# Staff Report

Infill Housing Design Review Committee

File Number: 2-H-25-IH

**Location:** 3339 Divide St. **Parcel ID** 81 P B 002  
**Zoning:** RN-2 (Single-Family Residential Neighborhood)  
**District:** Lonsdale Infill Housing Overlay District

**A-1**

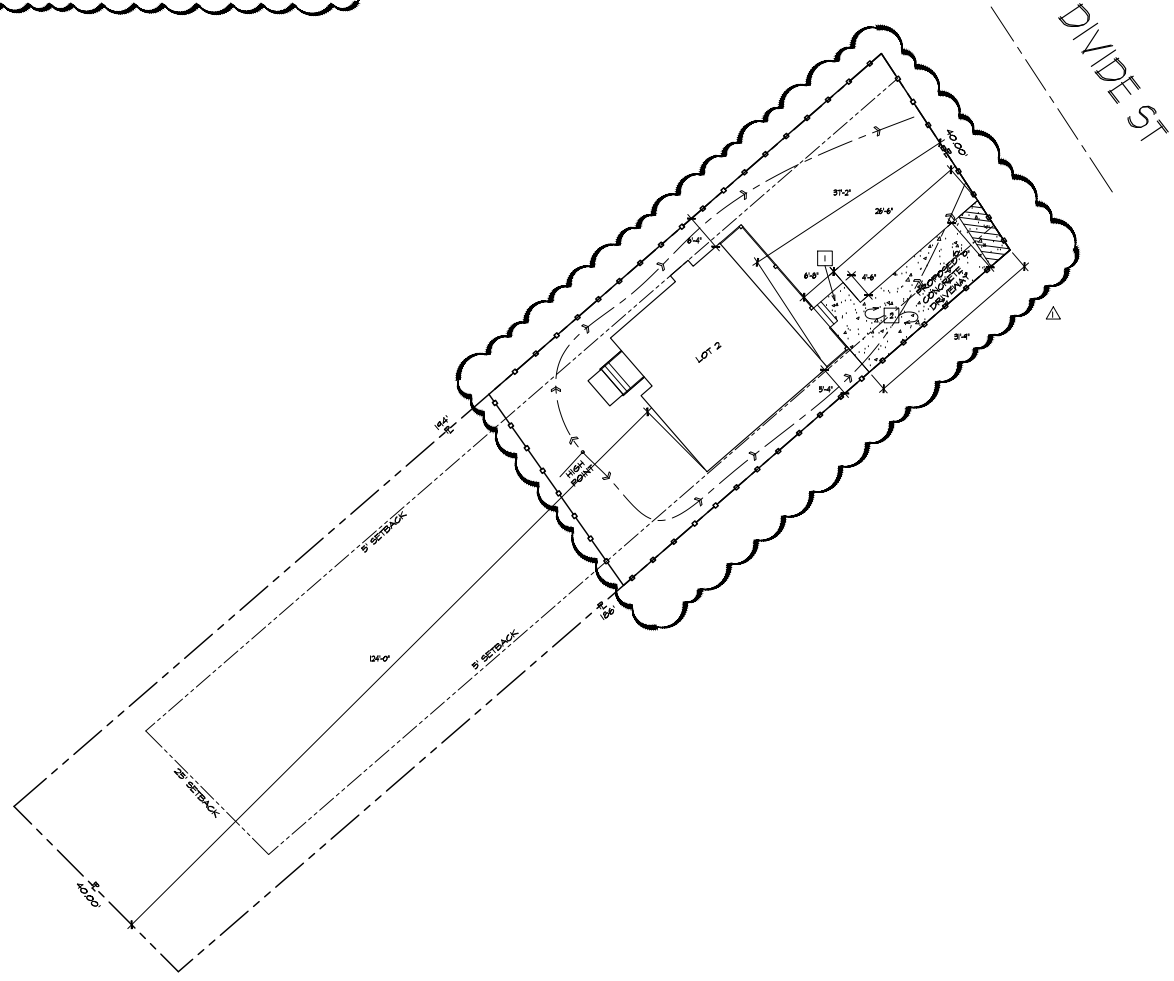
1. The house is proposed to be set 37'-6" from the front property line. The final site plan should be revised to add a front walkway that connects with the street.

3. Infill Housing design guidelines recommend that on lots without alleys, new driveways should be at least 20' behind the front façade of the infill house with access limited to one lane between the street and the front façade. Parking is a concrete pad located in front of the house and accessed via a driveway from Divide Street. Parking should be revised to avoid the front yard.

9. The final site plan should be revised to include a native or naturalized shade tree in the front and back yards.

ELEVATIONS

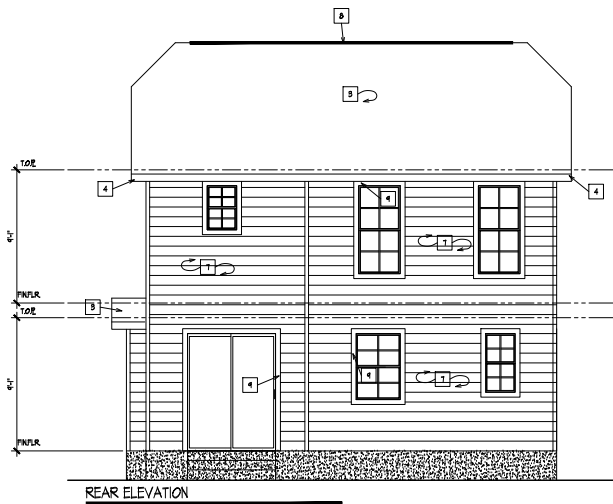
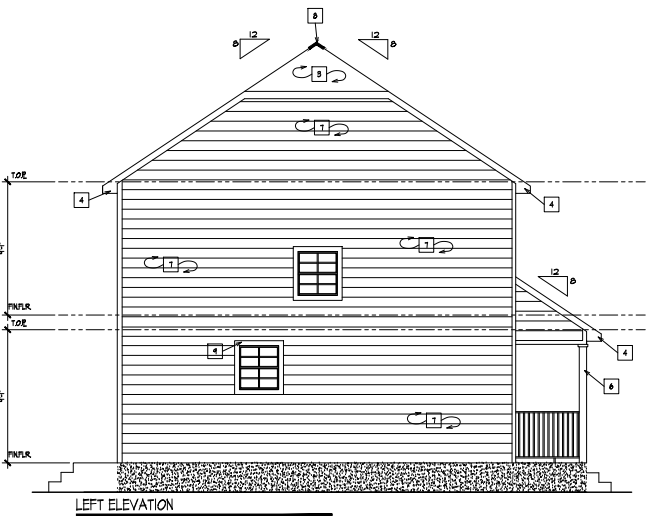
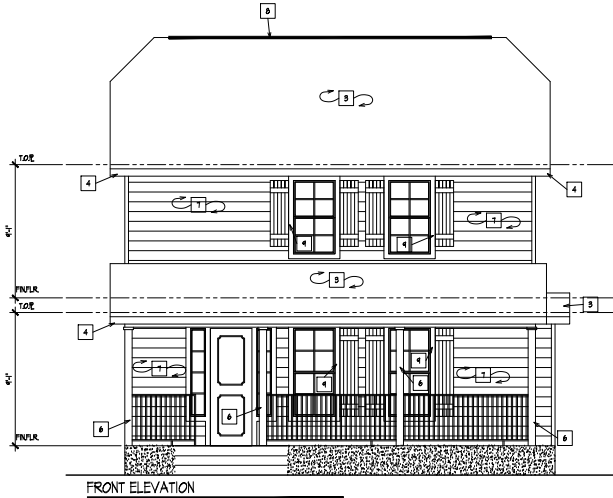
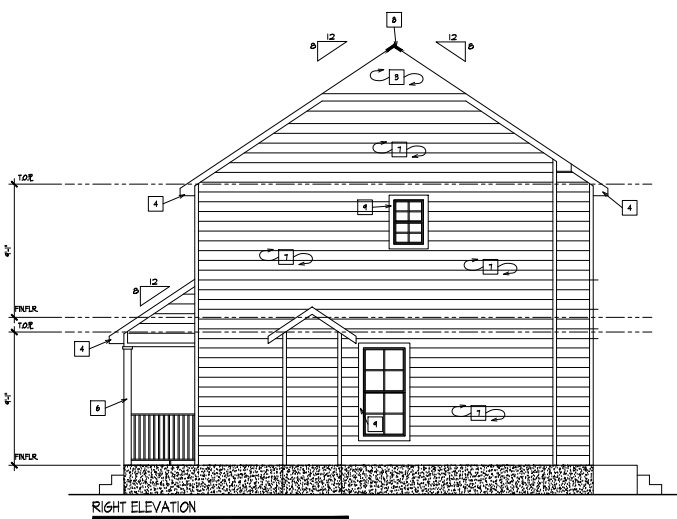
4. The two-story, three-bay façade is not similar in scale and height to the context, which almost exclusively features one-story houses with balanced façades.

5. The house features a full length, 4'-4" deep front porch recessed under a shed roof and supported by four square wood posts. Guidelines state that front porches should be proportional to other houses on the block and at least 8' deep. The porch depth should be revised to at least 8'.

6. Guidelines recommend window and door styles be similar to historic houses on the block, with similar placement and ratio of solid to void. The façade should be revised to avoid the half-shutter on the left first story window. The 4/4 single-hung windows are compatible with the 6/6 single-hung windows on most houses in the block, and the façade and rear elevations feature a sufficient ratio of solid to void. However, the house features five different window sizes, and the windows are placed at different heights on the side elevations, leaving large swaths of siding. The window sizes and placement should be revised to be more cohesive. The paneled door flanked with sidelights is appropriate.

7. The 8/12 roof pitch matches the context and benefits from the complexity of the clipped gables.
8. The asphalt shingles and horizontal vinyl siding meet the design guidelines, but the siding should be clapboard-style with an overlap instead of Dutch lap or flush panel siding. The foundation appears to be a concrete slab, which should be clad in stucco or parge-coated to meet the design guidelines.
